AW-95-908

November 30, 1995

SUBJECT: WESTINGHOUSE RESPONSES TO NRC REQUESTS FOR ADDITIONAL
INFORMATION ON THE AP600

Figure 440.492-13 NOTRUMP - Core Collapsed Liquid Level for Test SB09

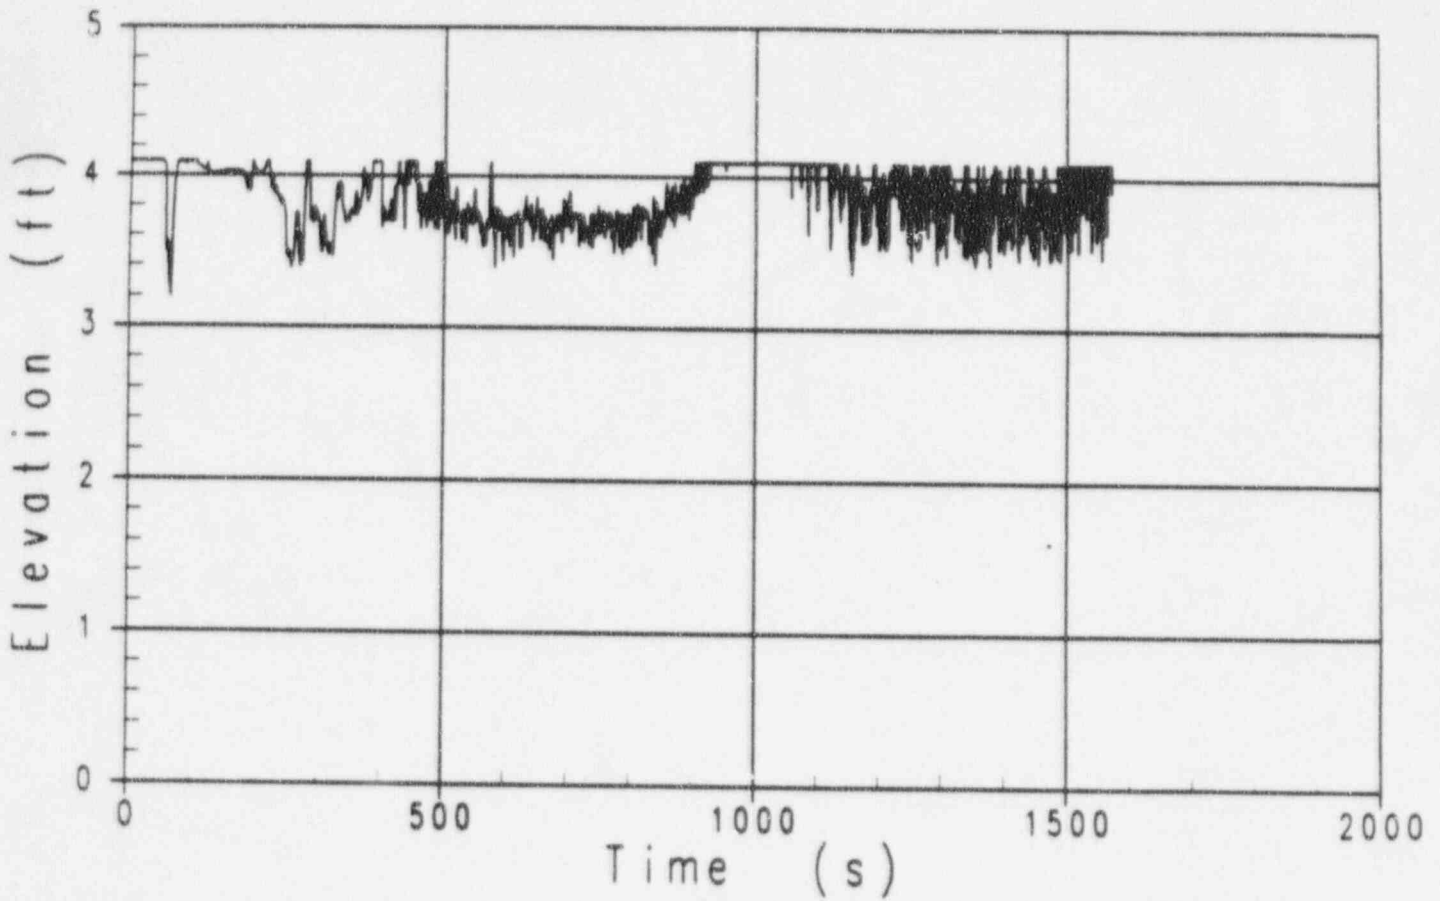
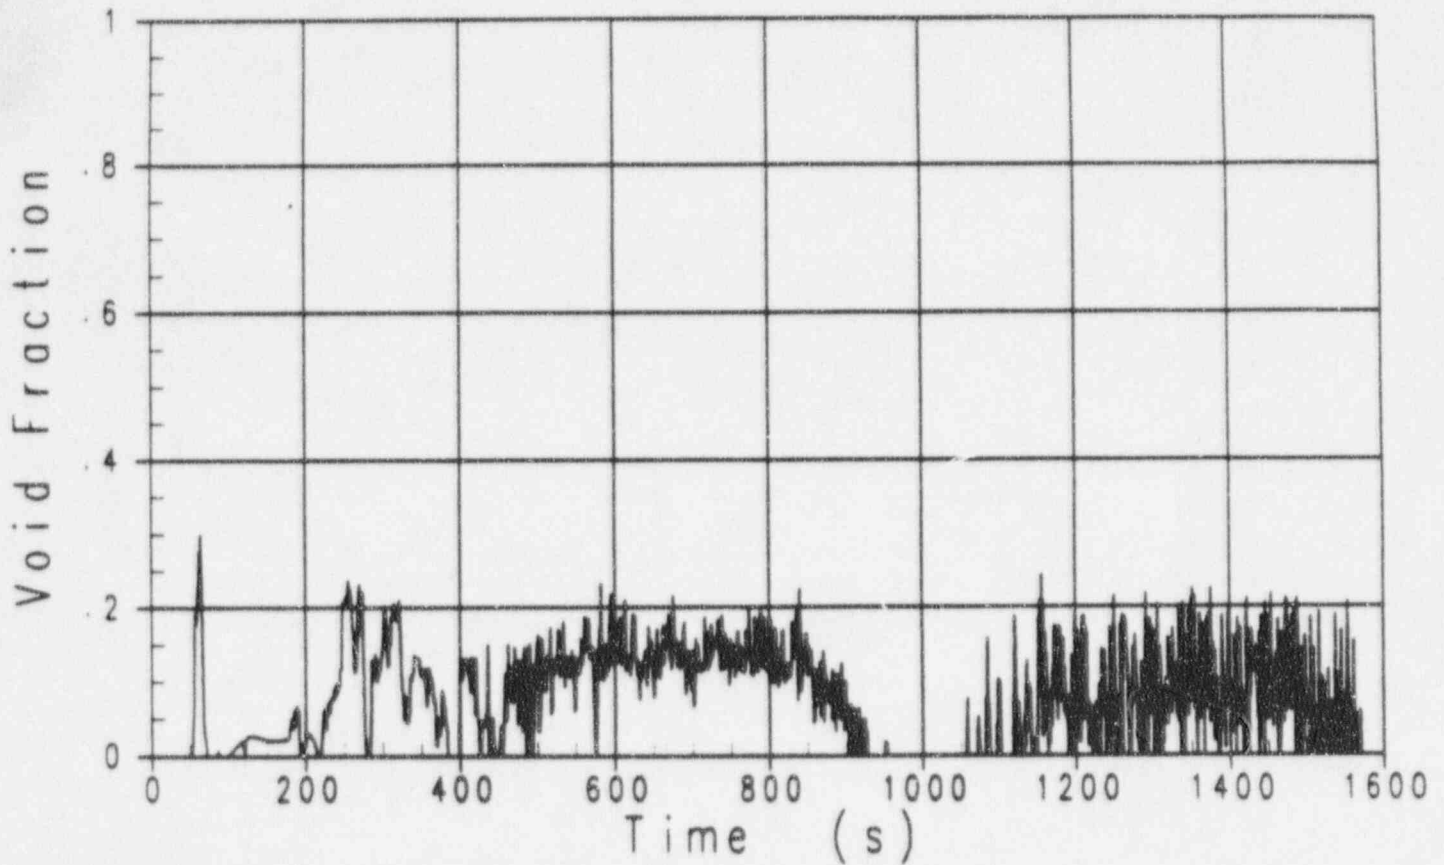
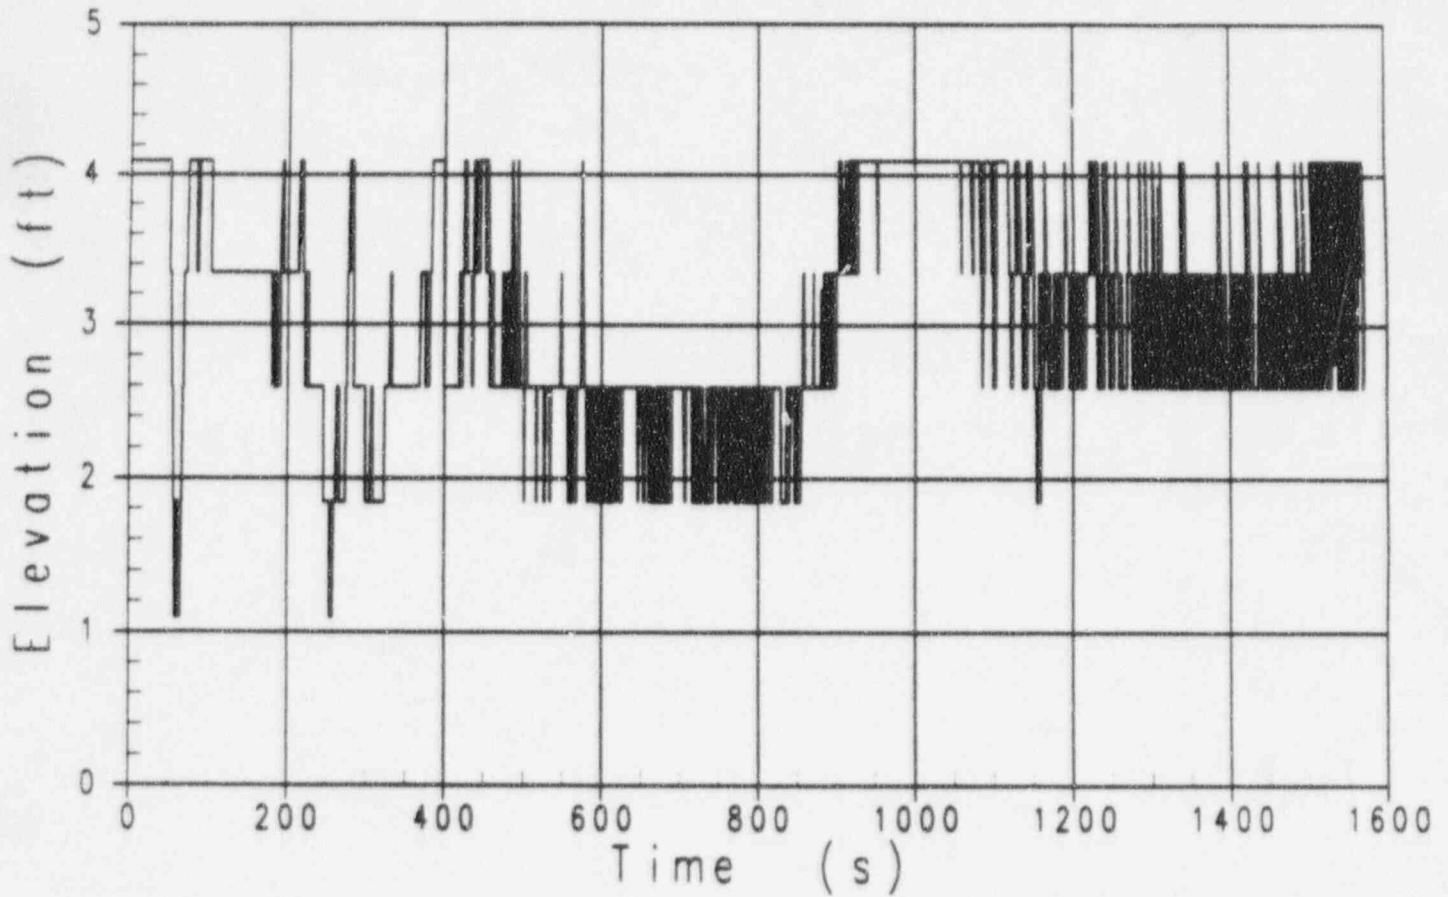
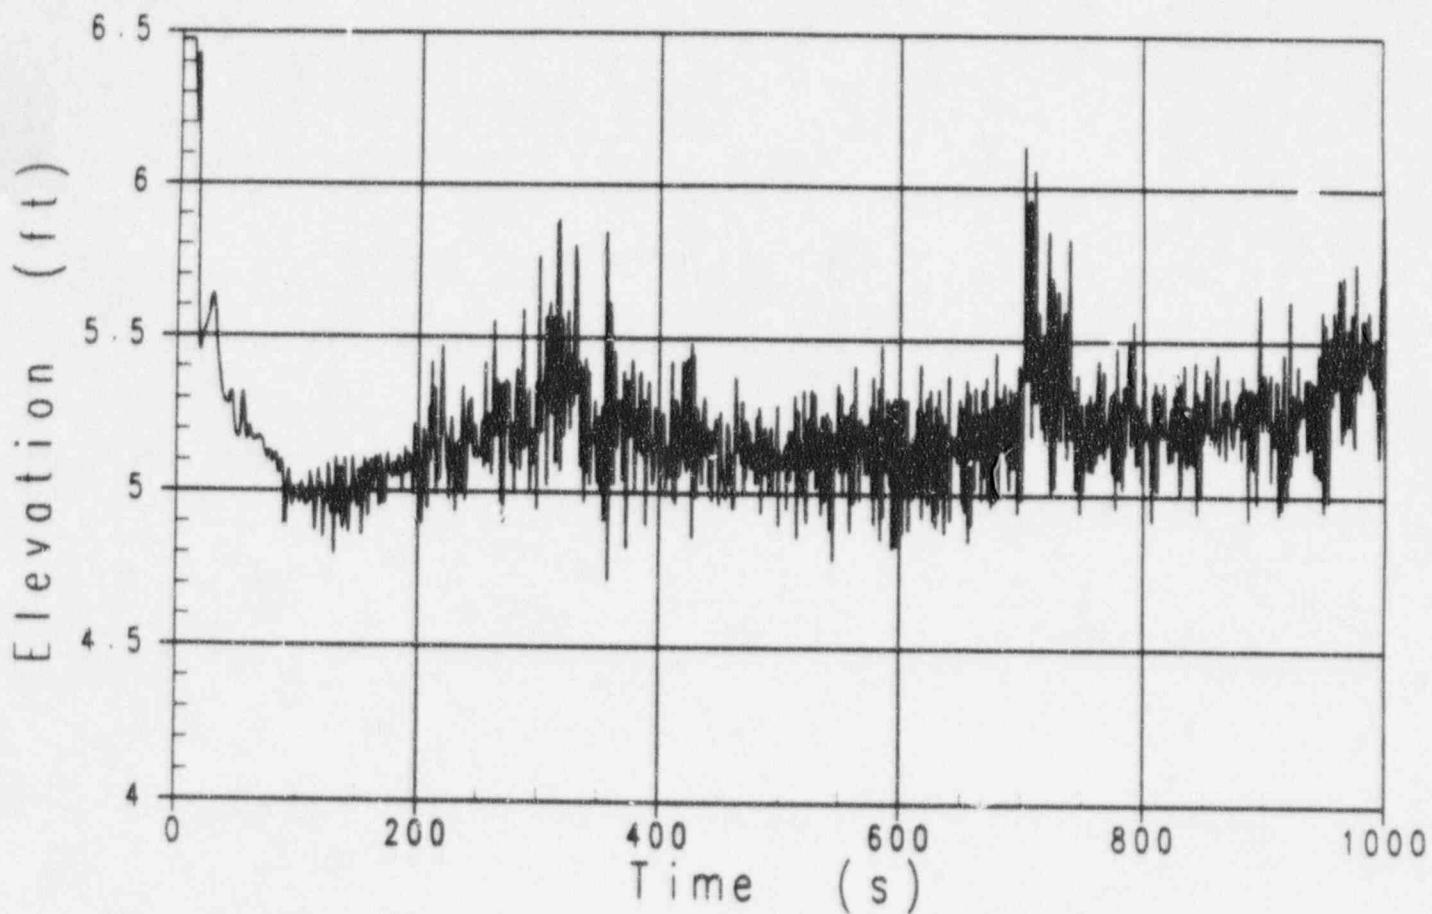
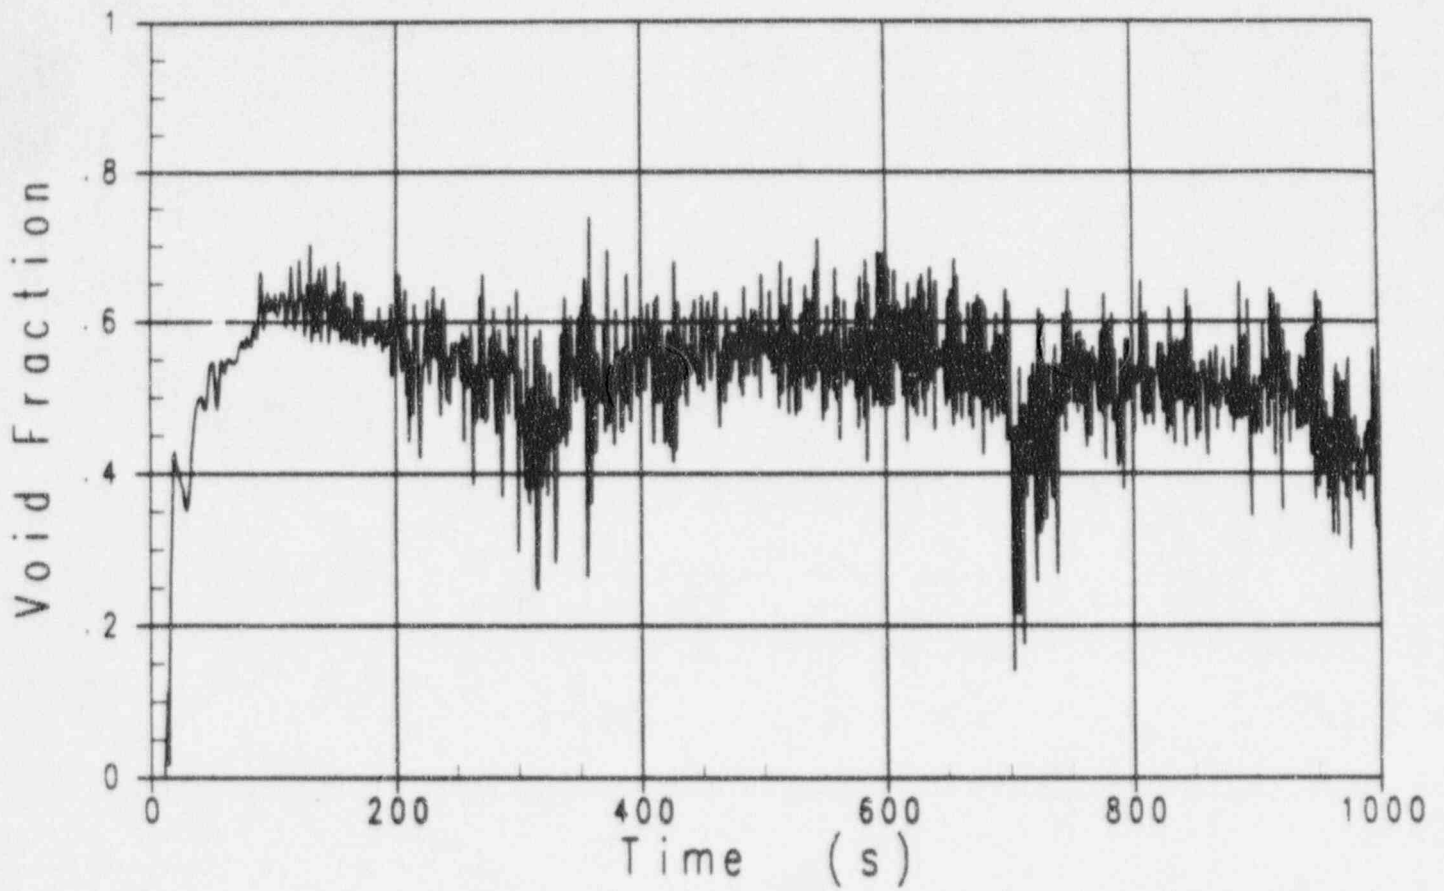
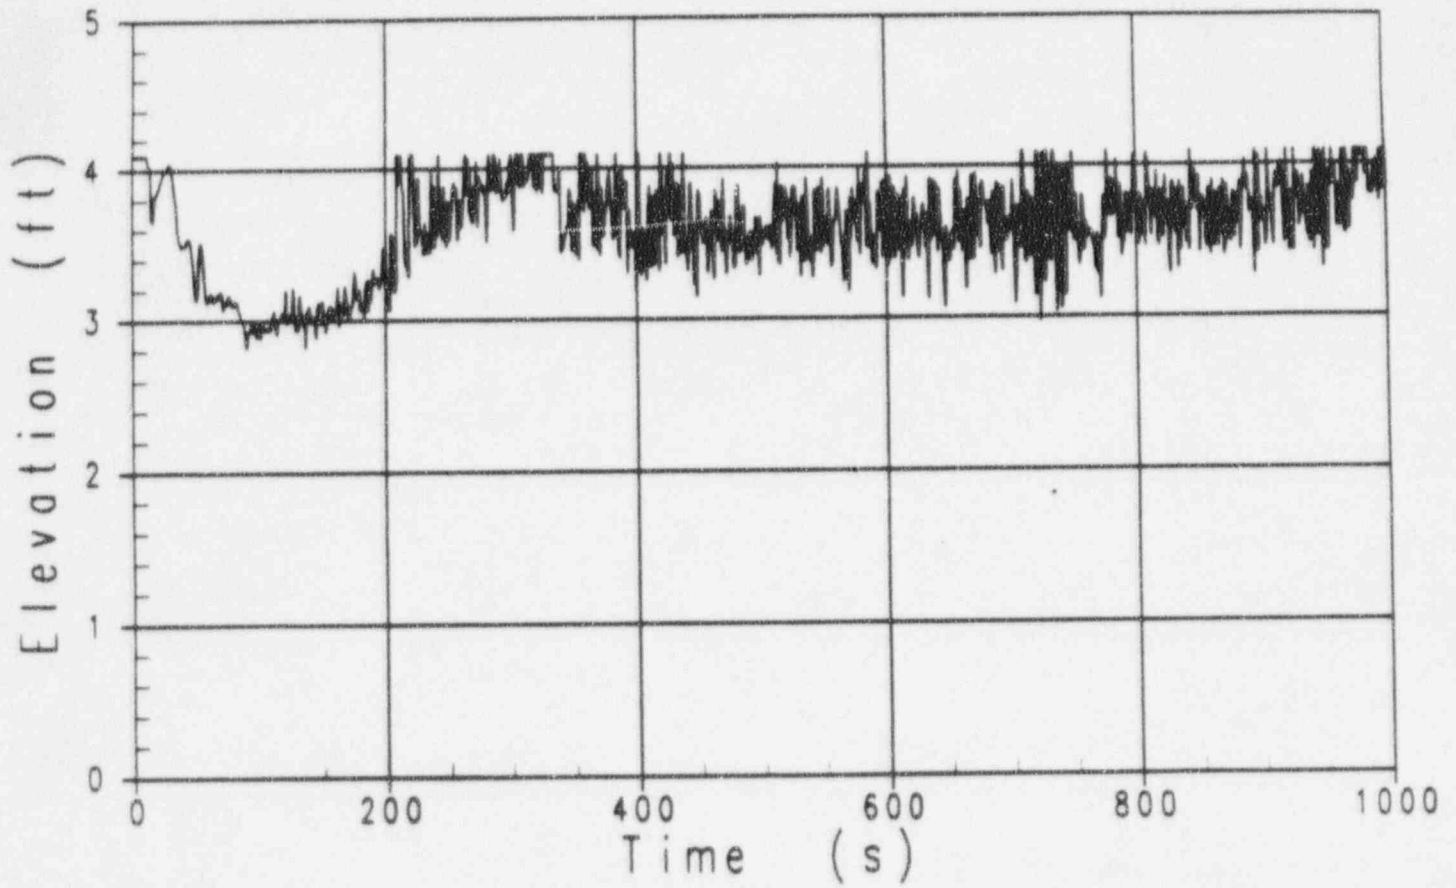
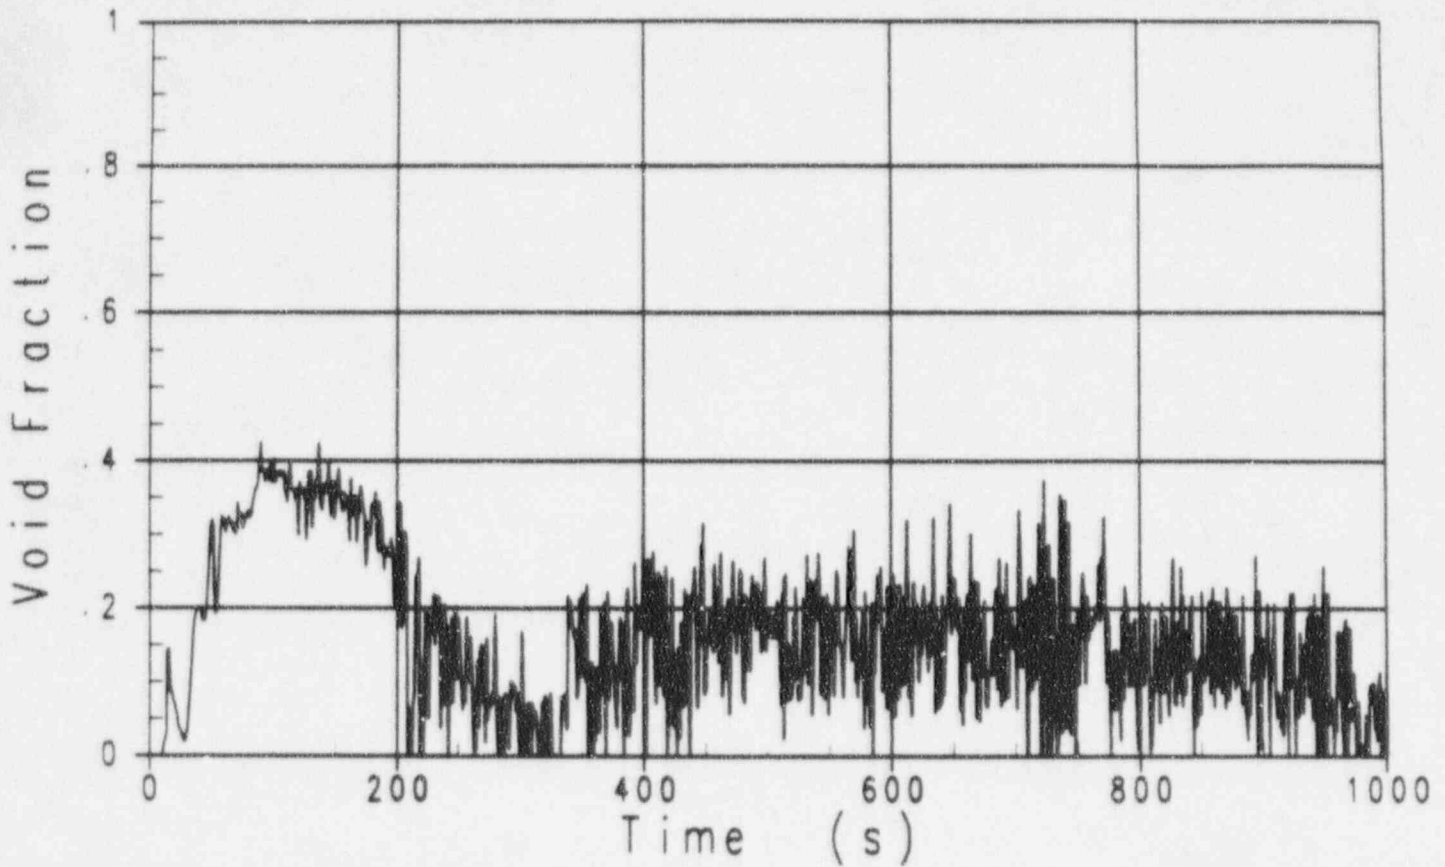
Please provide the core inlet and bypass mass flow rate predictions for the blind two inch cold leg balance line break of Section 5.2. Also, provide the liquid level plots for the upper plenum and core region and the void distribution in the core region.

The requested NOTRUMP core inlet and core bypass mass flow rate predictions for this test are provided in the response to RAI 440.491.
